HISTORIC PRESERVATION REVIEW BOARD STAFF REPORT AND RECOMMENDATION

Landmark/District: The Harrison Flats (x) Agenda

Address: **704** 3rd **Street NW**

Case Number: 18-106 (x) Addition

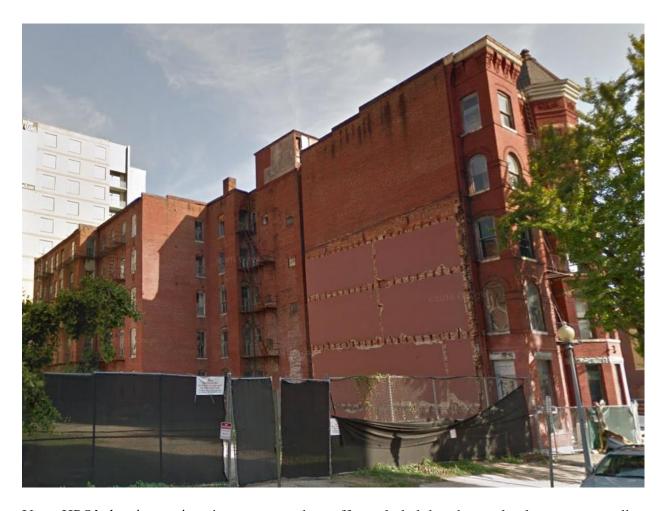
The condition of the building has declined dramatically since the staff first toured it about 2004. A structural engineer's report was submitted to the Board in 2011, outlining the major issues. Recent information is added on page 3 of the submission and in the attached narrative. Having gone through a succession of owners, it is difficult to apportion responsibility for neglect of the property, but not maintaining a sufficiently sound roof and secured window openings for some years caused a cascade of effects. Water entering the building has rotted much of the wood framing of the southern portion of the building and the roof. Especially with repeated freezing, the water has also caused movement in the masonry walls; the west, "rear" wall, made of common brick, is in the worst shape.

As previously, it seems that programmatic issues are the more compelling reason for removal of much of the rear wall. One section of this wall contains the most altered openings, and an adjacent section needs repair because of washed-out mortar and some failing window arches. On their face, they do not appear to be beyond salvage. Yet, the present proposal calls for slightly less demolition than the last (which had been slightly more than the two previous concepts).
